DEVIATION REQUEST AND DECISION FORM

Project Name : **BENT GRASS EAST COMMERCIAL FILING NO. 3**
Schedule No.(s) : 53011-01-060
Legal Description : Tract BB, Bent Grass East Commercial Filing No. 2B

A deviation from the standards of or in Section **2.2.4.B.6 and 2.5.2.B.3** of the Engineering Criteria Manual (ECM) is requested.

**BENT GRASS EAST
COMMERCIAL FILING NO. 3
PEDESTRIAN ACCESS EXHIBIT**

TYPICAL PRIVATE ROAD CROSS SECTION

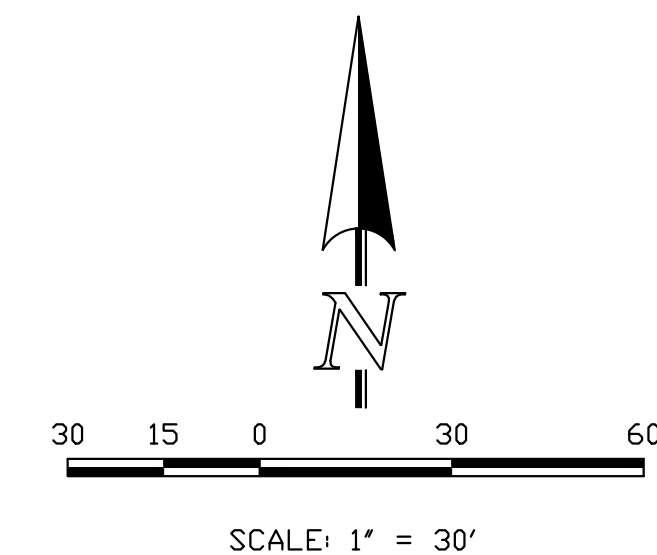
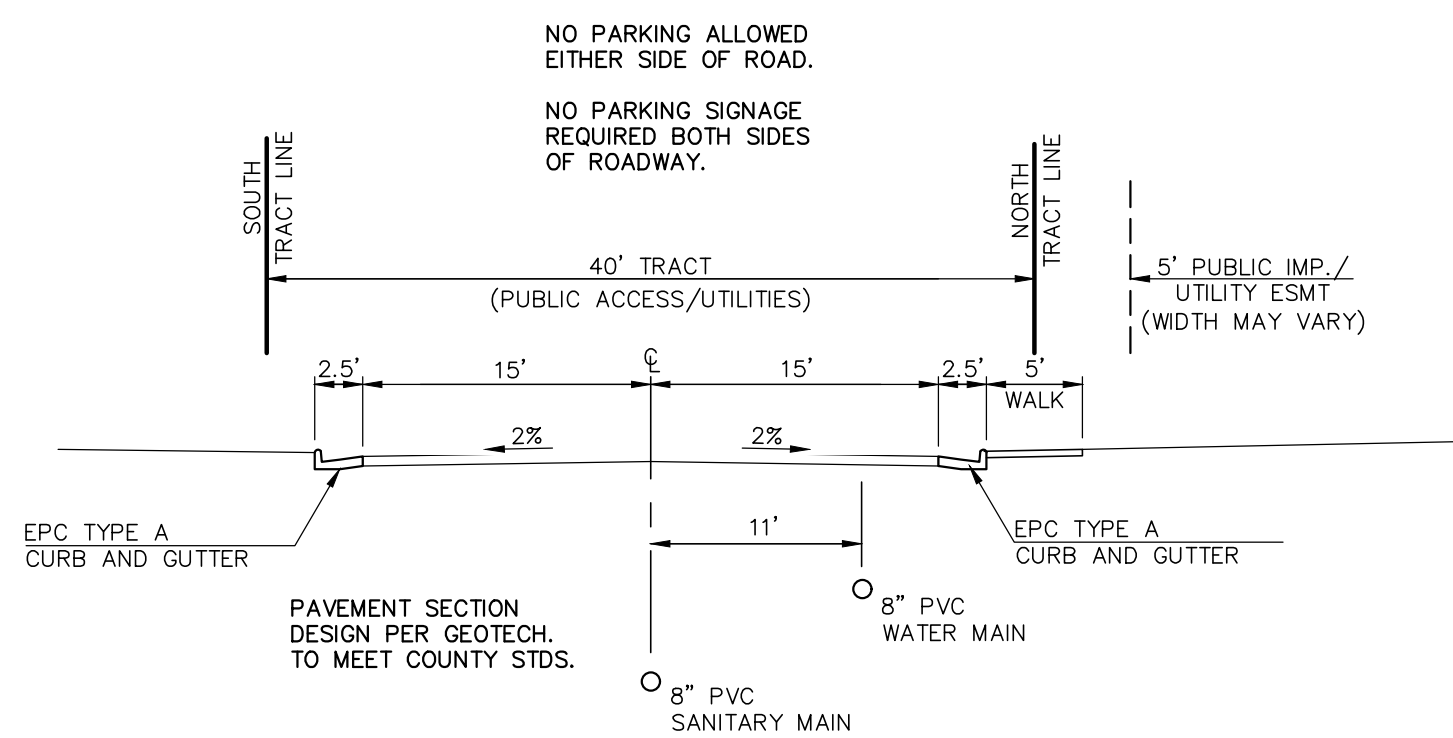
A private roadway is proposed (30' paved width)

Min. CL curve Radius proposed is 100' compared to the 200' for Local and 100' for Local low-volume. (Reference attached truck turning exhibit showing adequate site access)

Private roadway Tract width proposed is 40' compared to std. 50' Right-of-Way with esmts. Additional esmts. provided for utilities and sidewalks.

Paved width proposed is 30'. This width is consistent with the County std. urban local roadway.

Sidewalk (5.0' attached) is proposed along one side of the private roadway only with two mid-block pedestrian ramp crossings compared to both sides for Local.

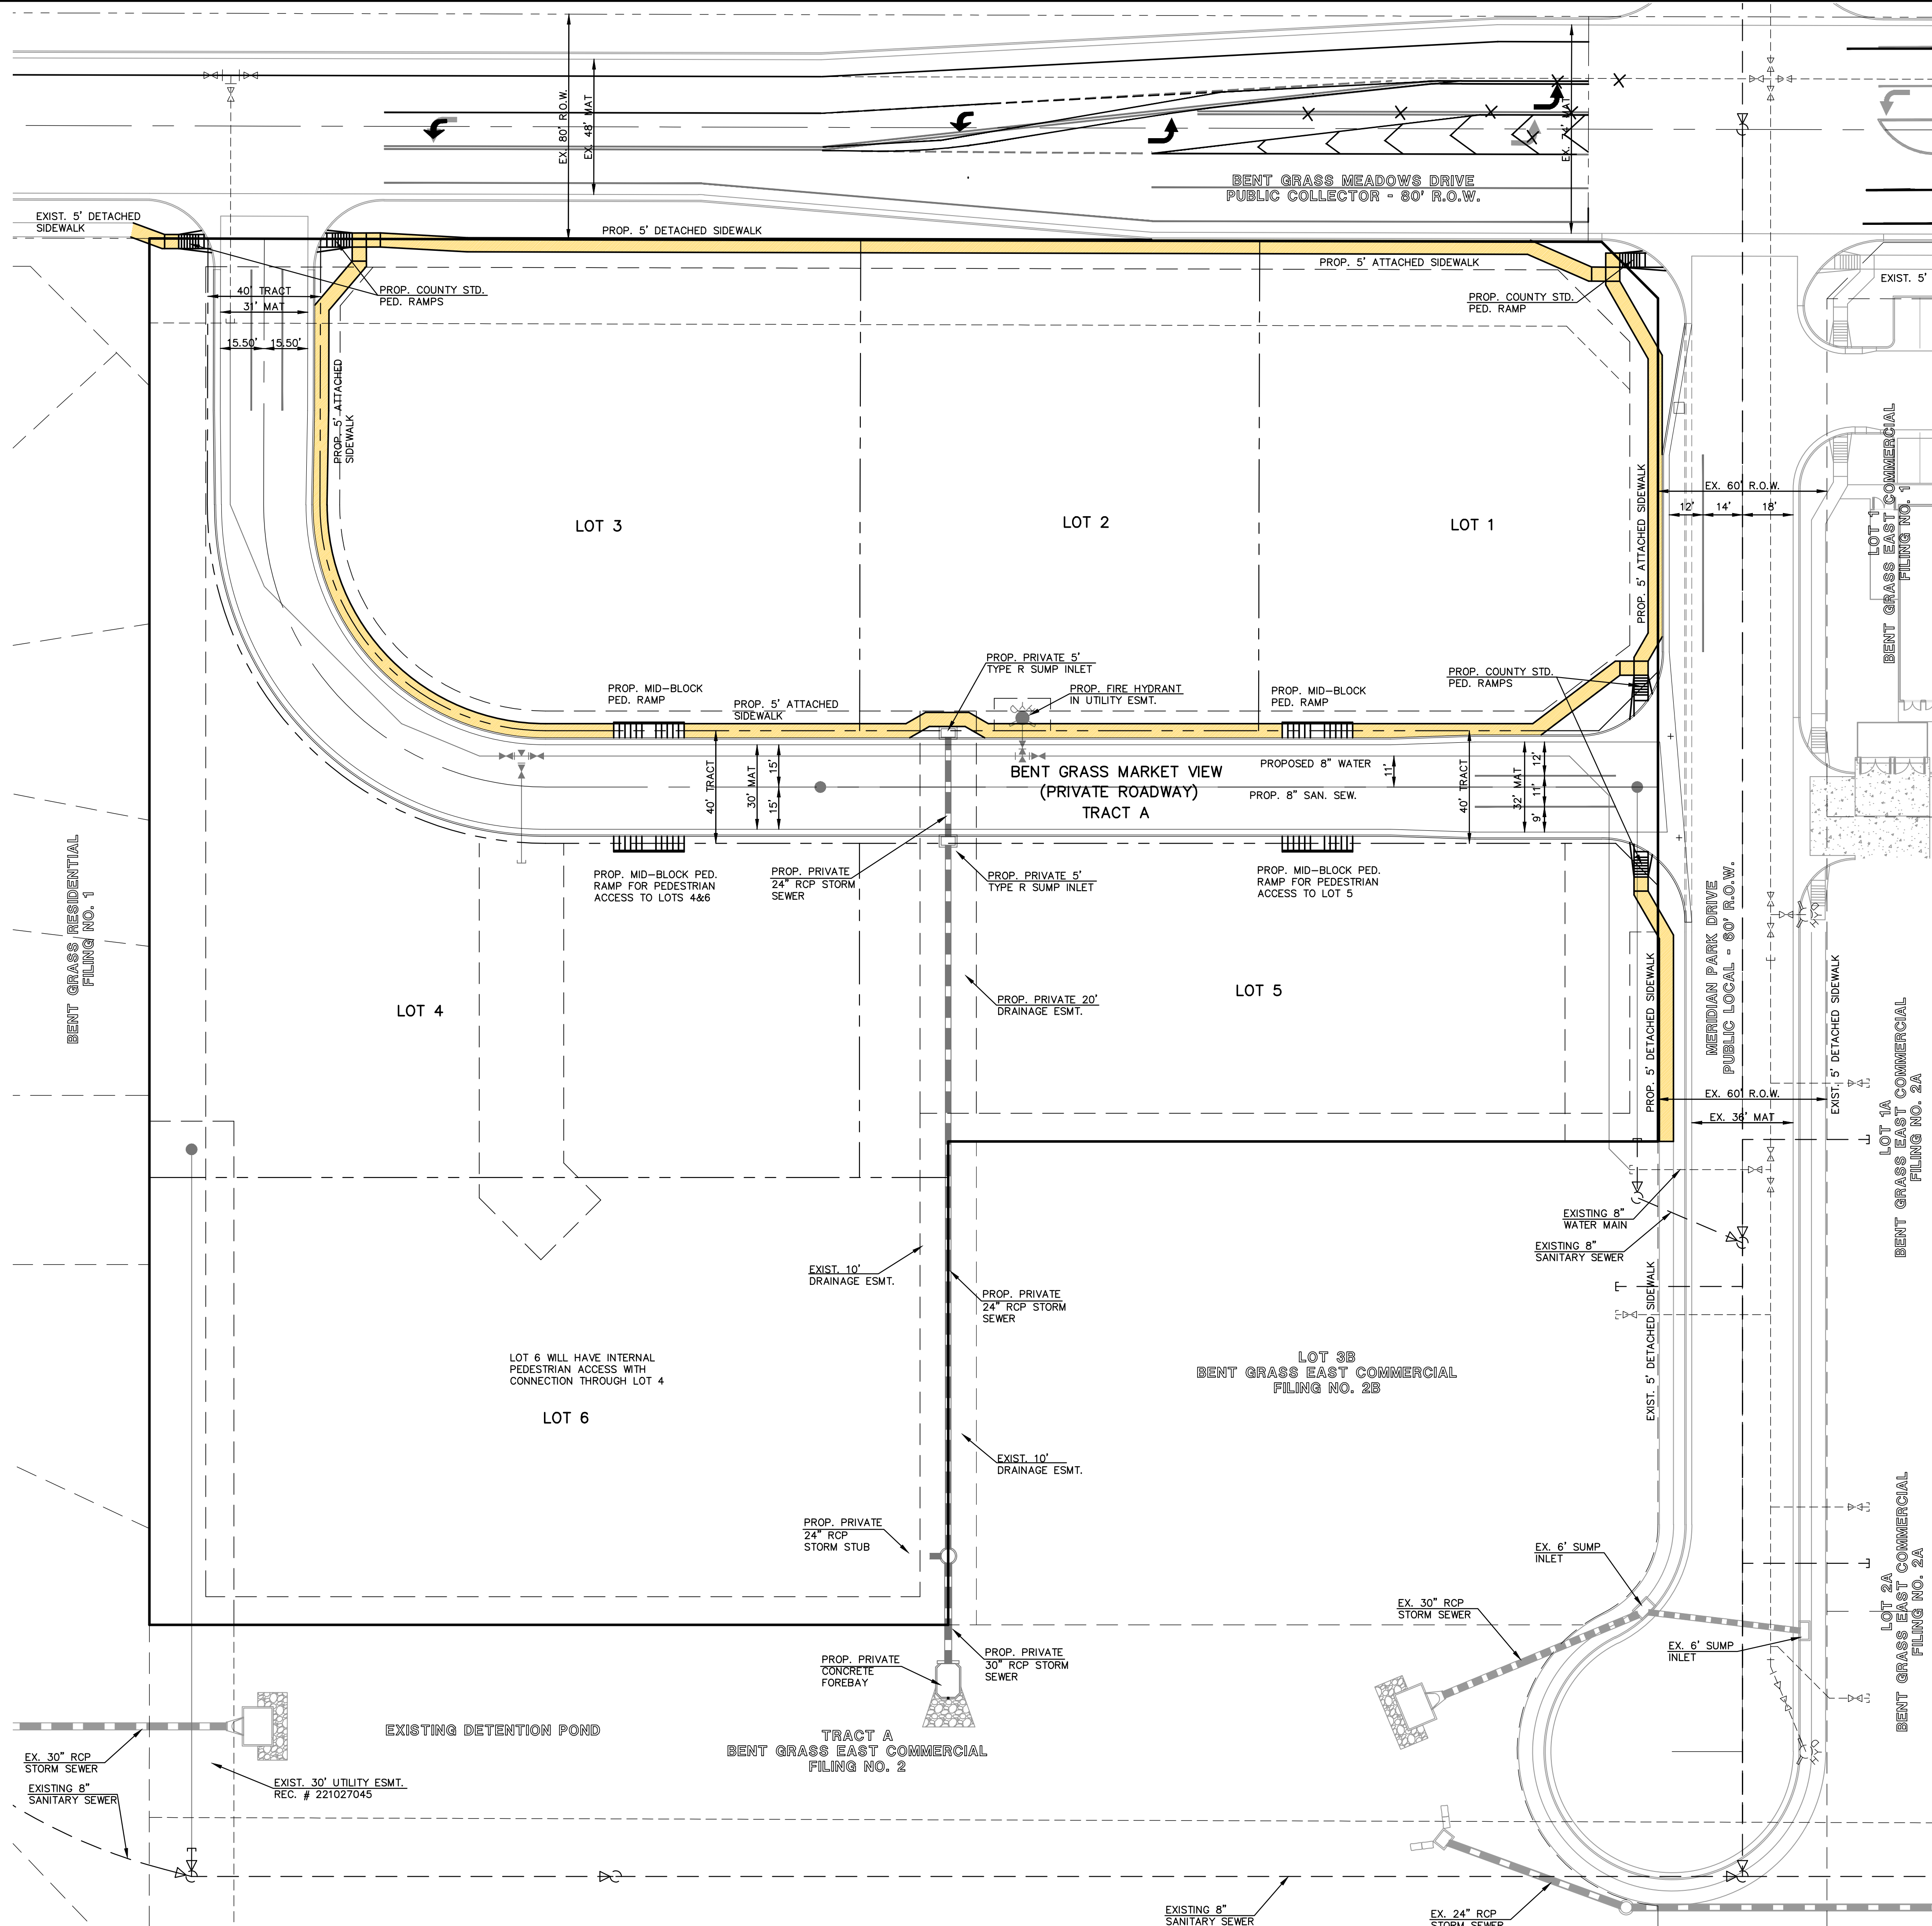
The ECM does not provide an option for a private roadway for a commercial development such as this. A public Right-of-Way meeting all the County stds. limits the development ability for a commercial project like this. A private roadway with similar yet modified design aspects from the ECM std. will allow for adequate access without compromising public safety or accessibility. Per the TIS, the proposed private roadway design seems to be adequate to handle the site generated traffic. Per the provided truck turning exhibit for B-40 bus, the proposed CL radius provides adequate truck access through the site. Pedestrian access is provided to each lot with the proposed 5' attached sidewalk on one side of the road along with two mid-block pedestrian ramp crossings. Sidewalk is also provided on the perimeter of the site adjacent to Bent Grass Meadows Drive and Meridian Park Dr. which allows for further pedestrian circulation.

TRUCK TURNING EXHIBIT
(B-40 BUS)

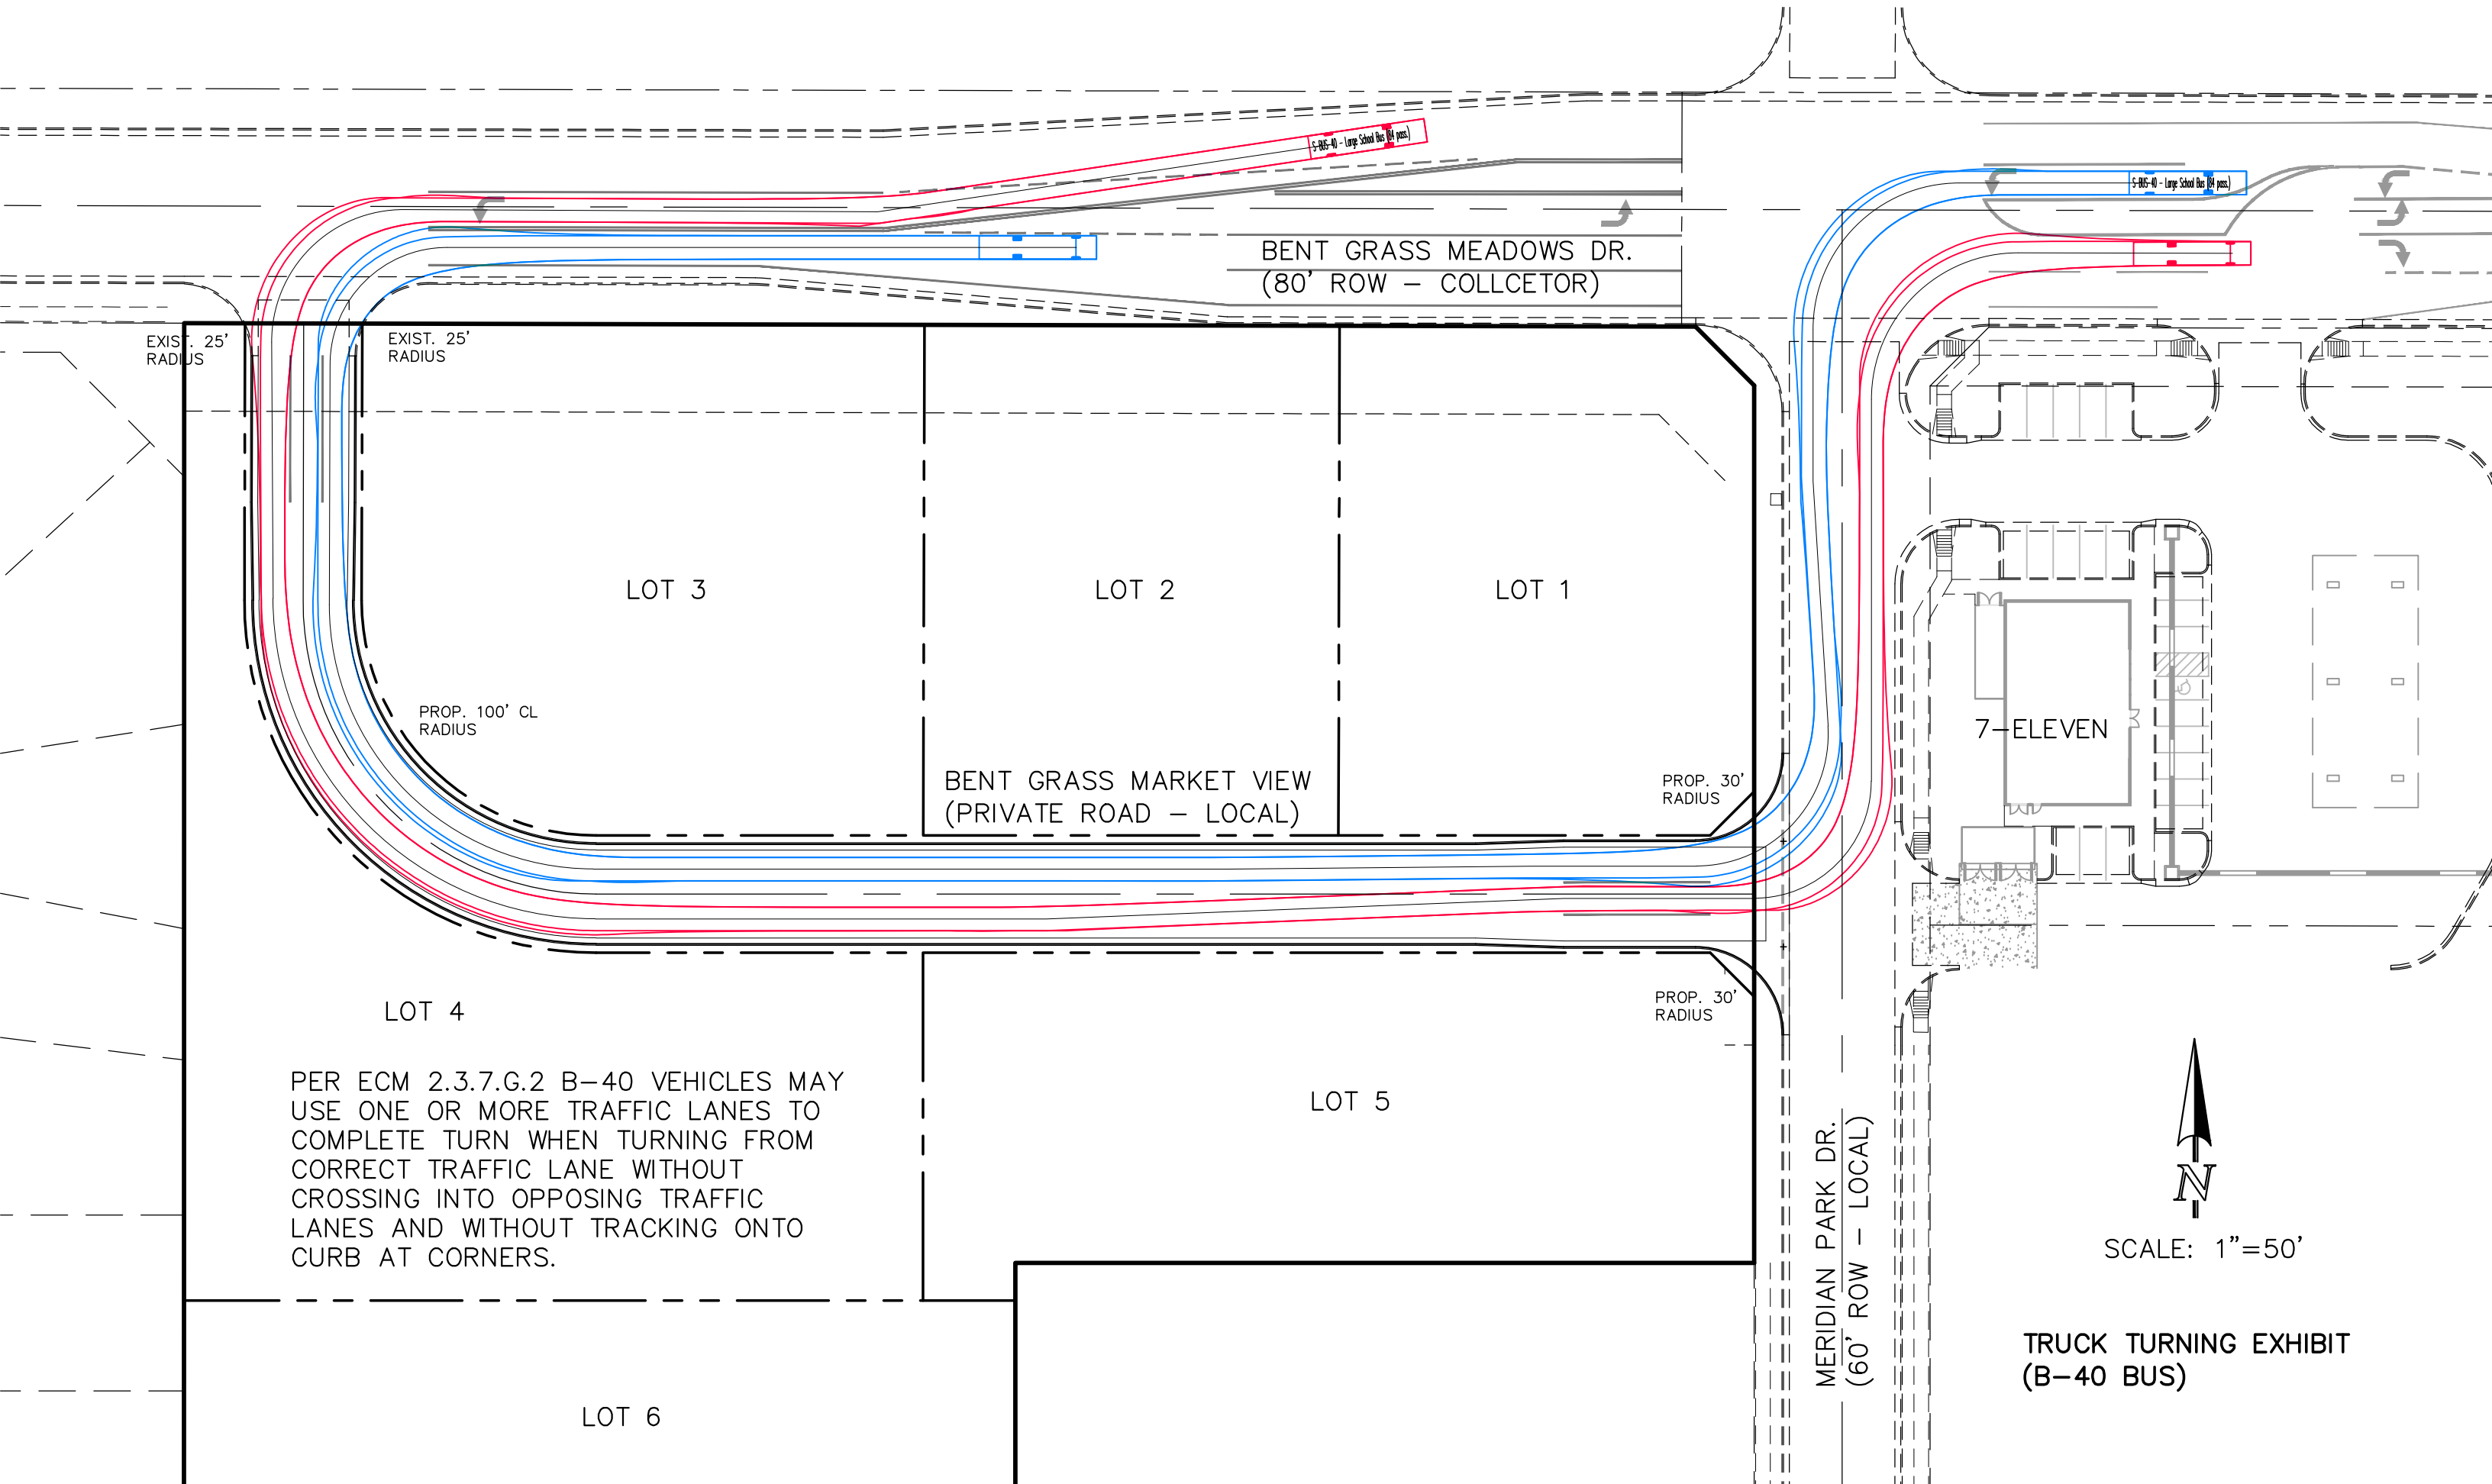
PER ECM 2.3.7.G.2 B-40 VEHICLES MAY
USE ONE OR MORE TRAFFIC LANES TO
COMPLETE TURN WHEN TURNING FROM
CORRECT TRAFFIC LANE WITHOUT
CROSSING INTO OPPOSING TRAFFIC
LANES AND WITHOUT TRACKING ONTO
CURB AT CORNERS.
